UNITED STATES DEPARTMENT OF COMMERCE
National Institute of Standards and Technology
Gaithersburg, Maryland 20899

Subject: NRC Request for Additional Information (RAI's) dated

Docket No. 50-184

**Response to NRC RAI's
May 30, 2007**

The correct Figure 4.5.19 is below:

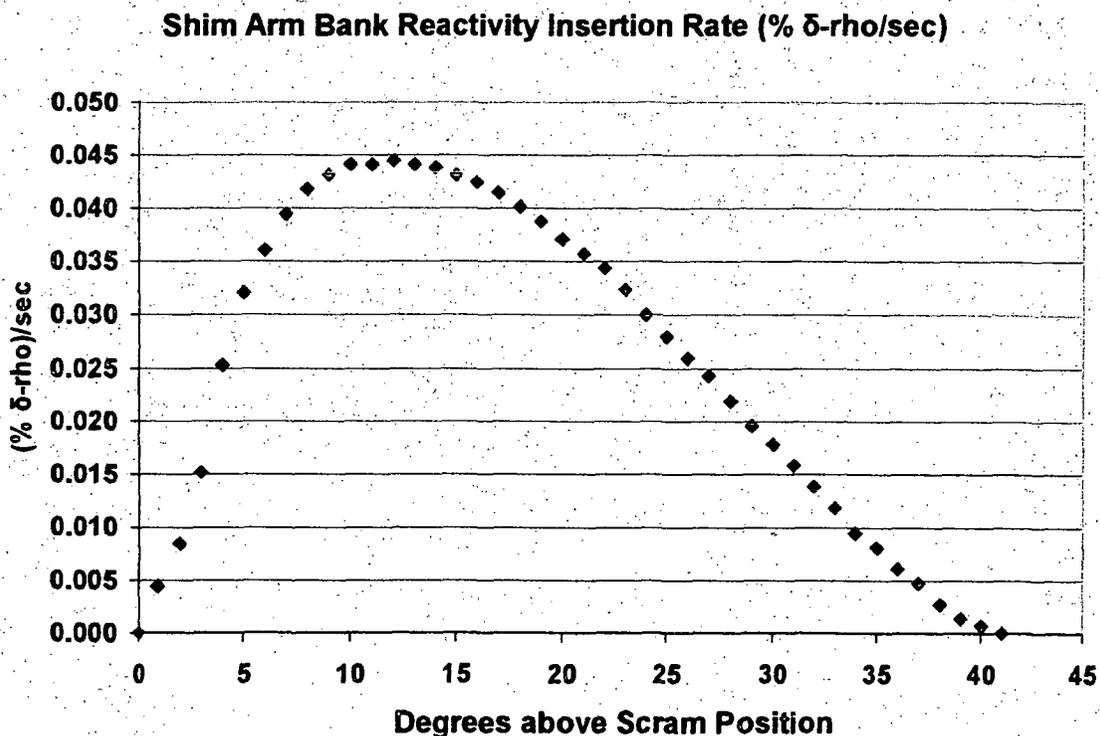
- 4.20 Section 4.5.1.5.1, p. 4-34. The second paragraph states "Multiplying the differential shim bank reactivity worth by the speed of the shim arm drives, 0.0445 °/s, one obtains the reactivity insertion rate vs. position, shown in Fig. 4.5.19." This does not appear to be what is shown in Figure 4.5.19. Clarify the statement or modify the figure to be consistent with the statement.

MAJOR SCRAM CIRCUIT

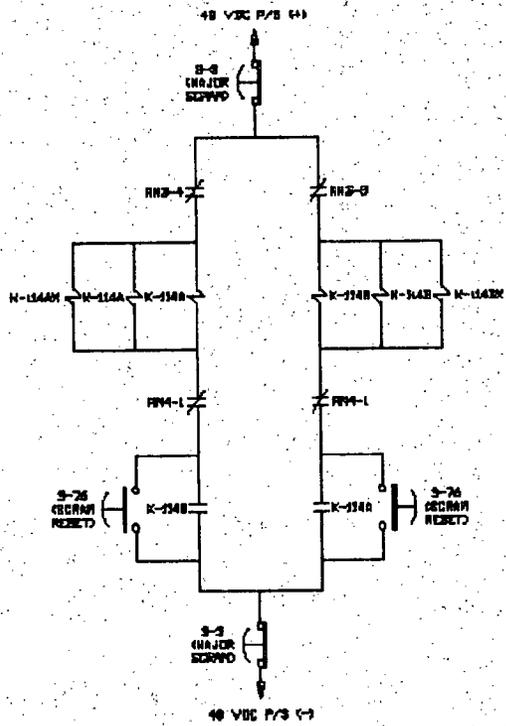
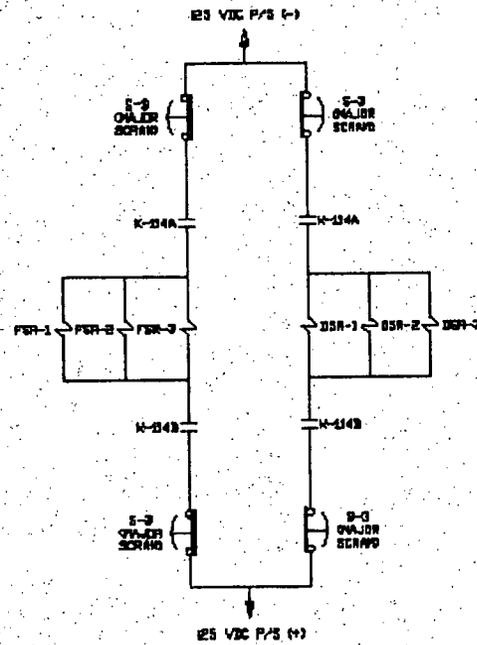
- 7.2 Section 7.2.3, p. 7-10. Provide a schematic of the control logic for confinement building isolation, i.e., door scram relays, fan scram relays, ventilation system alignment, etc.

Response: The text from Section 7.2.3 on page 7-10 is repeated here: The Major Scram function is part of the RPS. The Normal Air Monitor Channel, Irradiated Air Monitor Channel and the Stack Monitor Channel control relays in the Major Scram circuit. Upon the detection of an excessive activity level by any of the three channels, the Major Scram relays scram the reactor and initiate Confinement Building isolation. The Major Scram relays open contacts in the Scram logic string, thereby initiating a reactor scram. The relays also shut the doors at the entrances to the Confinement Building by tripping the Door Scram Relays (DSR), shift the ventilation lineup to recirculation mode by tripping the Fan Scram Relays (FSR), and close the Neutron Guide Isolation Valves. A new simplified schematic of the control logic is found below.
